**LEGAL ADVERTISEMENT
HISTORIC PRESERVATION BOARD
CITY OF PORTLAND
Public comments are taken at all meetings.**

HISTORIC PRESERVATION BOARD AGENDA
March 18, 2015, 5:00 p.m. - Room 209, Portland City Hall

**PUBLIC HEARING
147 CONGRESS STREET**

ALUMNI HALL – UNE WESTBROOK COLLEGE

Proposed View from Congress Street

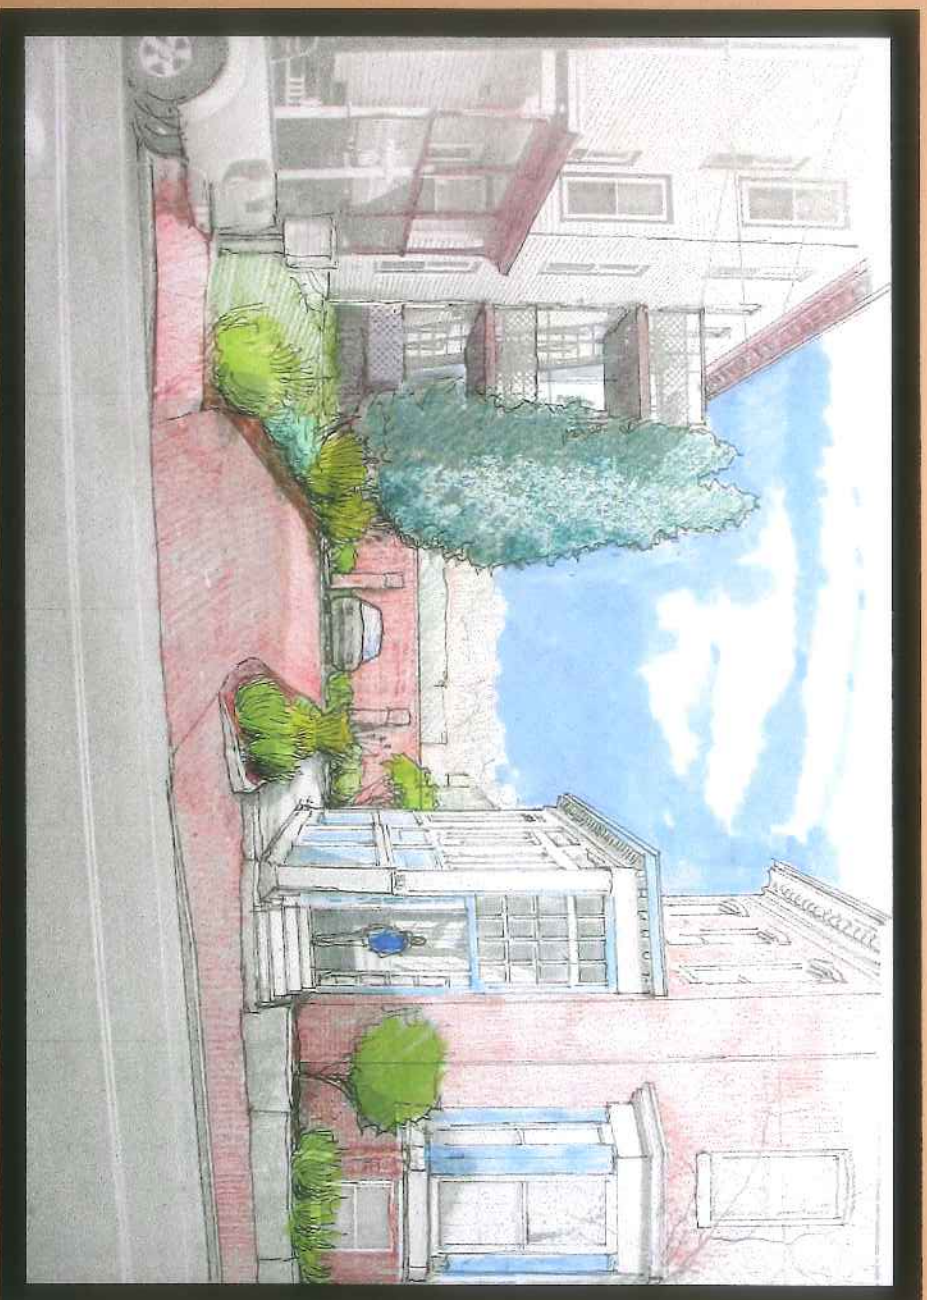
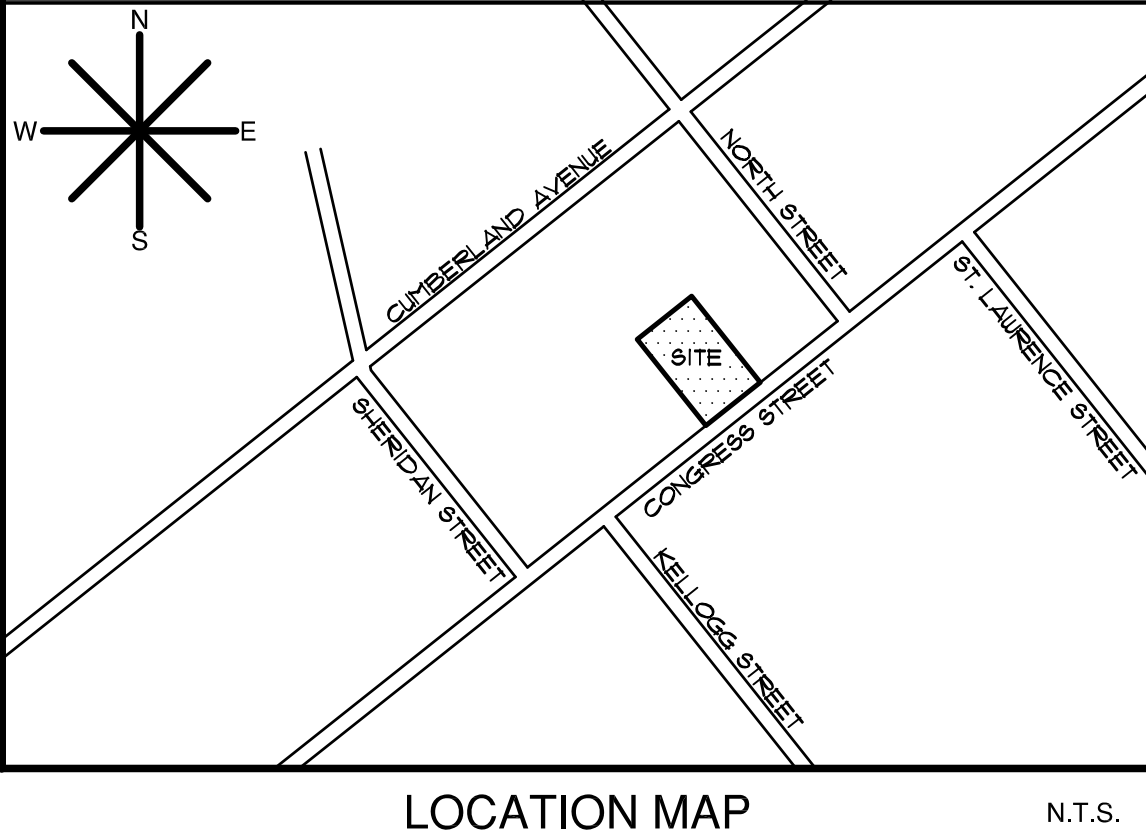
In support of the HPB's consideration of the proposed design, we have prepared the enclosed renderings showing the anticipated view of the plan from the Congress Street perspective. The images show two conditions, the first image shows a vehicle parked in the center spot on the site. This spot is the most visible location to see a vehicle, as the existing buildings and vegetation on the site would shield and/or buffer the view of a car parked in any other spot. The second image shows the view with no car in that spot, as would be expected to be typical during the workday.

Although a vehicle can be seen parked in the rear of the site, we are confident that the removal of the parking from the immediate and very prominent location along the street, coupled with the relative scale and elevation of the brick wall along the rear property line demonstrate that the change in parking configuration on the site, along with the various other site improvements combine to provide an acceptable site layout.

SKETCH PLAN - 14-REVISED
OF:
147 CONGRESS STREET
147 CONGRESS STREET
PORTLAND, MAINE
FOR:
CONGRESS 127 APARTMENTS, LLC
P.O. BOX 6285
CAPE ELIZABETH, ME 04107

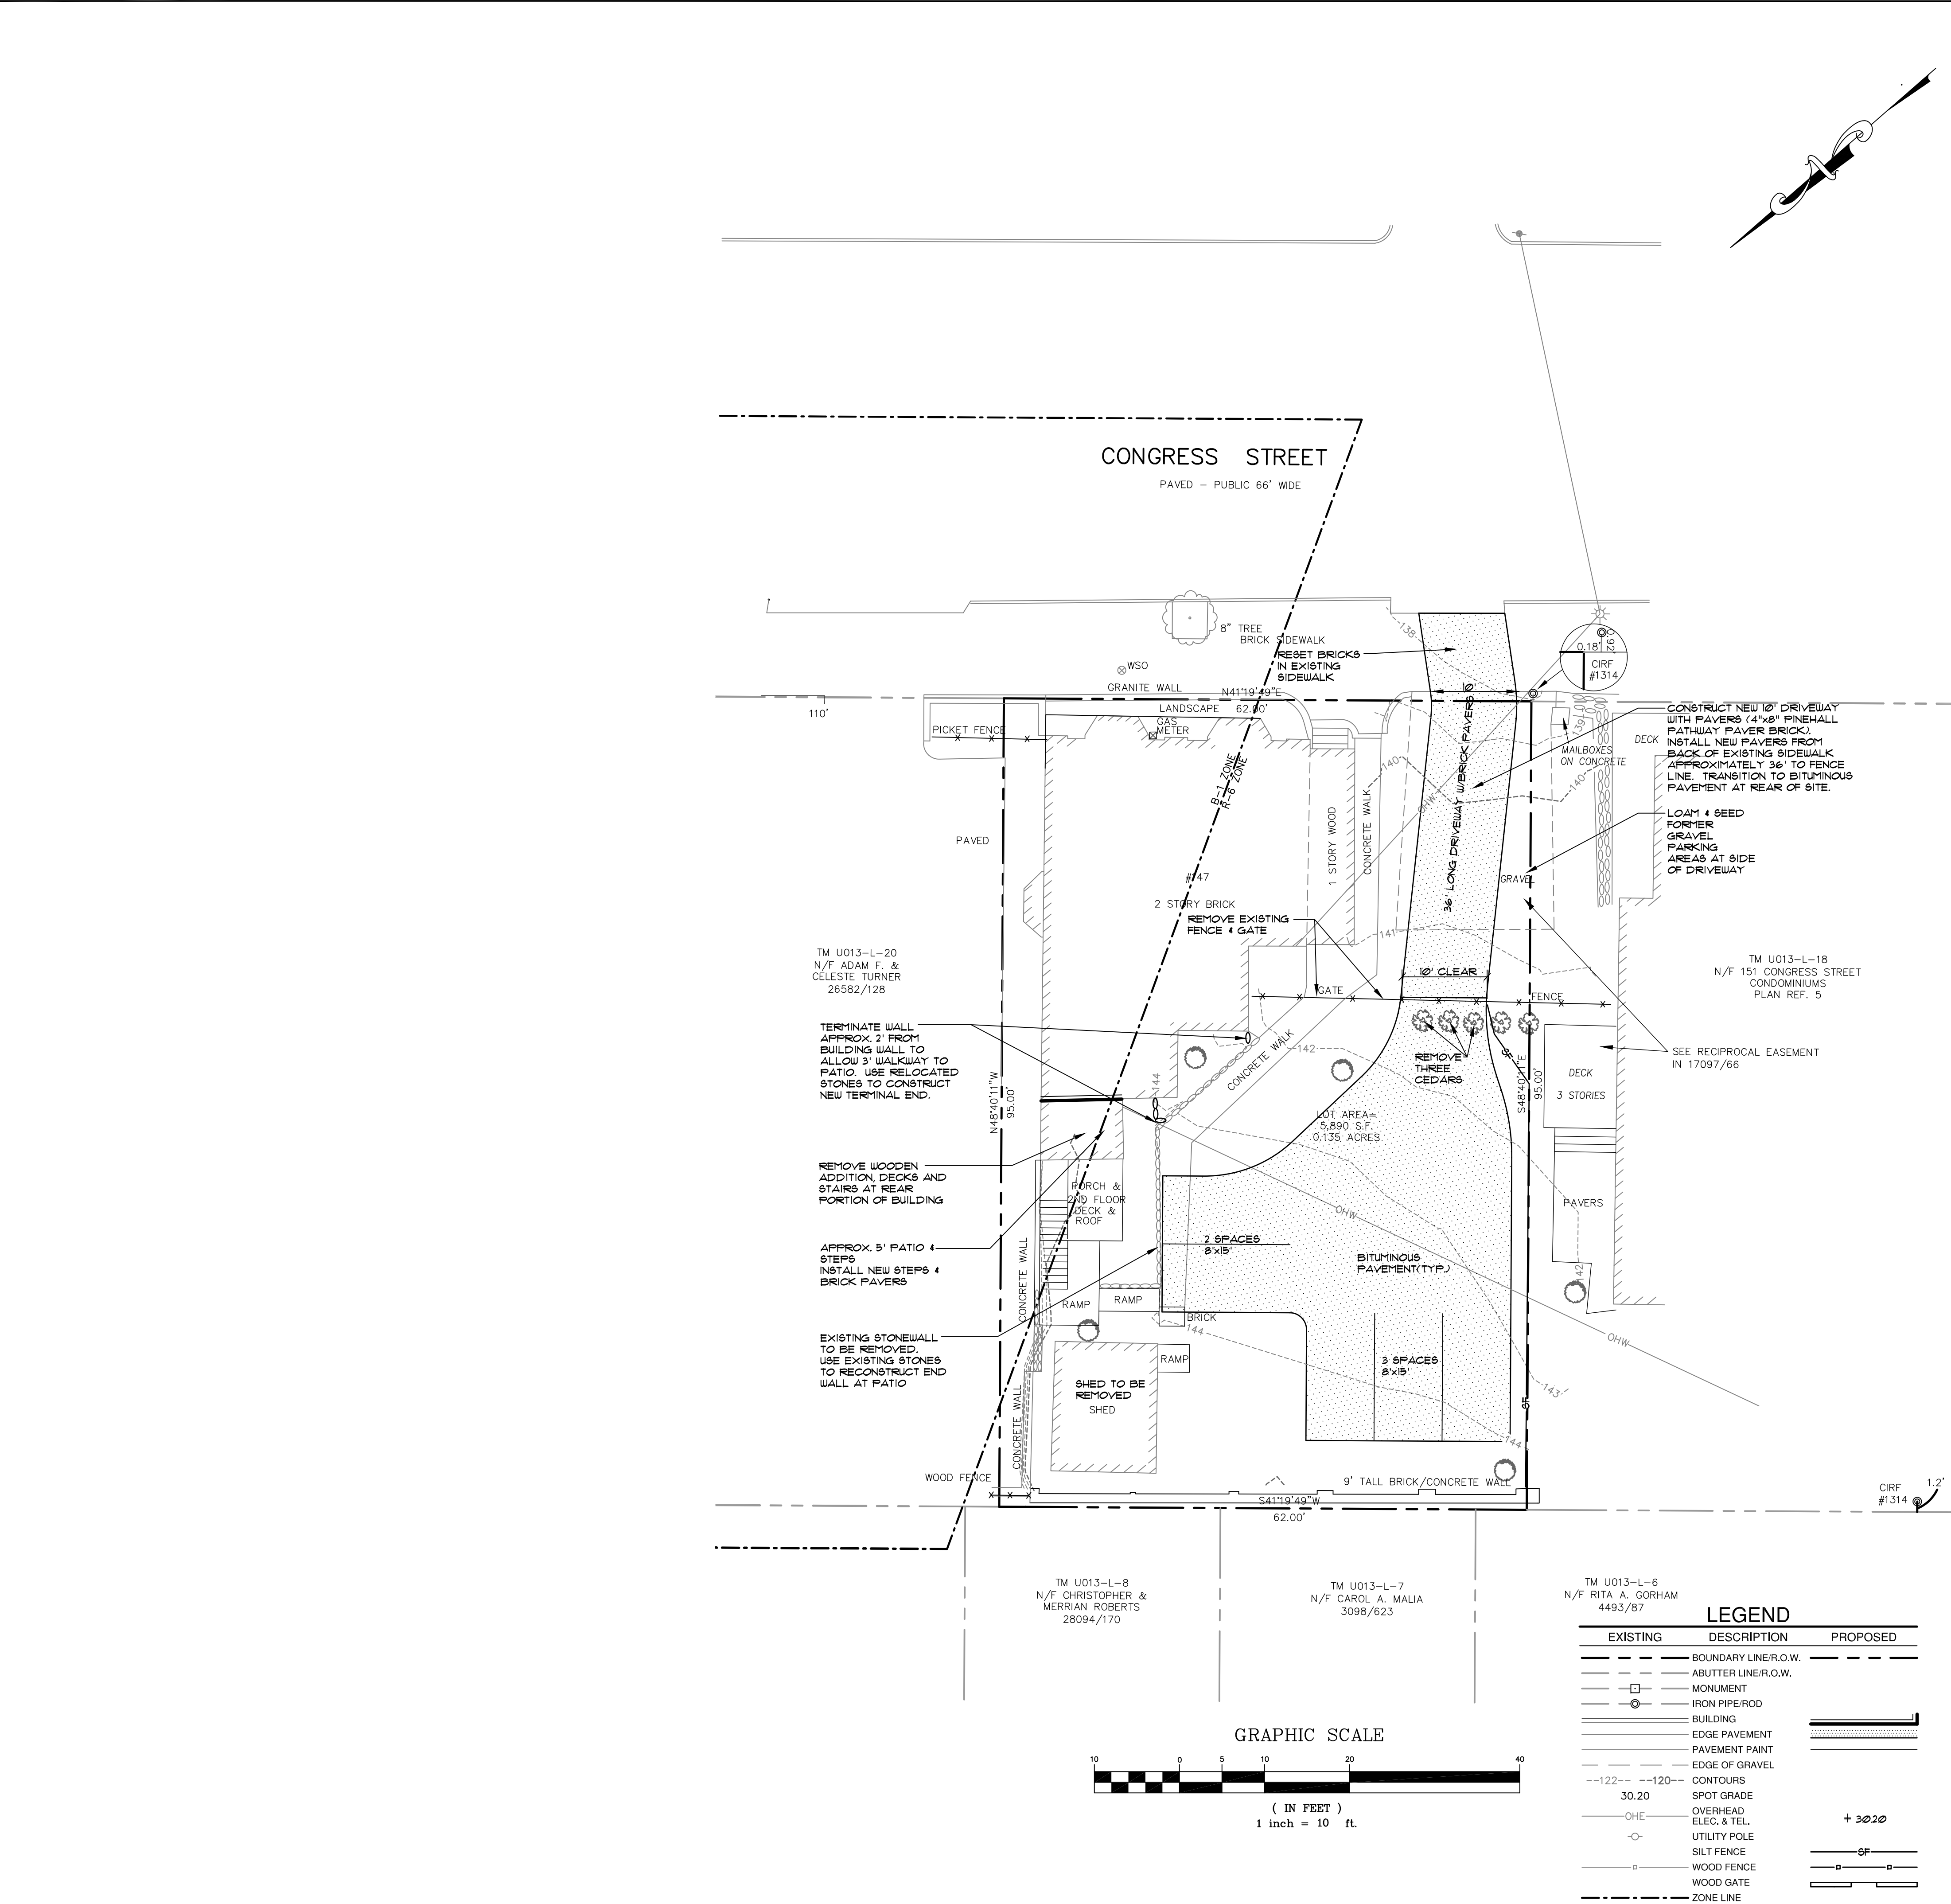
- Sketch Plan 13 was not favored, and could be eliminated as an option.
- The fence and gate proposed in January to block visibility of rear parking spots from Congress Street should be eliminated.
- A consistent 10' width was favored for the driveway, all the way to the sidewalk.
- Providing green space as a buffer between the rear of the house and the parking will be key to any acceptable solution.
- Planting of trees and other vegetation could help soften the site and partly ameliorate the impact of added parking.
- The existing brick rear garden wall is a notable feature of the property, and care should be taken to protect it from neglect, the weight and pressure of cars and site alterations, poor drainage, and tree roots.
- All Board members appeared to favor more visibility of the brick garden wall than currently exists.

Sketch Plan 14 was favored for the following reasons:

Staff believes that if a compatible five space parking plan is possible for the property, Sketch Plan 14 is the direction that is most sensitive to the historic house. Sketch Plan 12, considered on March 4, emphasized the visibility of the brick garden wall and the invisibility of parked cars (both as viewed from the public way.) The final proposal, Sketch plan 14, is most sensitive to separating the rear of the house from parking, except for the two spaces designated for the residents of 147 Congress. Further, it provides the most viable, contiguous yard space behind the house. From the east side property line to the beginning of the deeded condo parking, the current proposal includes a rear yard that is more than thirty-five feet wide. (This "yard" includes the two parking spaces reserved for the house's residents.) Because the brick wall is tall and significant, it will still be visible with cars parked in the three western spaces (see Mr. Muench's rendering.) Staff does not believe the space behind the house – which is so important to creating a separation from the condo parking and green space for the residents – should be sacrificed for a totally unimpeded view of the wall.

On March 4, several Board members expressed support for one or another of the plans that might be contingent on a reduction from five to four parking spaces. Staff believes such a reduction would merely reduce the number of spaces offered to the residents of 147 Congress, as the applicants have made it clear they want to offer one space for each of three condos. If this current proposal is approved future owners of 147 Congress would be able choose to use only one parking space, and possibly expand the space available for other uses – unless a backing space is deemed necessary for the condo owners parking in the three spaces on the west side of the lot.

- On March 4 several Board members mentioned the possibility of an alternative to asphalt for the surface of some or all of the rear parking and circulation area. (Staff does not believe that the parking surface will be visible from the street, however.)
- Trees and other plantings have been mentioned as potentially important enhancements to any approved plan; does the Board want to tie approval to submission of a landscaping and planting plan?
- Tree roots could endanger the brick wall if trees are planted too close to it.
- The project will also require a Level 1 Site Plan Review, as well as review by the Zoning Board of Appeals.
- An evaluation of the condition of the brick wall may be warranted.
- An engineering review of the potential impacts of parked cars near the brick wall may be warranted.

As you know, the Applicant prefers SK-14 based on the attributes discussed at the March 4, 2015 meeting. Based on the feedback obtained during the workshop session and further review and deliberation among the team members, SK-14 has been selected as the preferred Plan and has been updated based on the feedback obtained.

This includes the elimination of any proposed fencing and gate. The width of the driveway has been reduced to provide a uniform dimension of 10' for the paver section between the Congress Street frontage and the rear of the site. This width allows additional landscaping to be planted along either side of the proposed driveway. This is in the area currently used for parking between the house and the adjacent multi-family building.
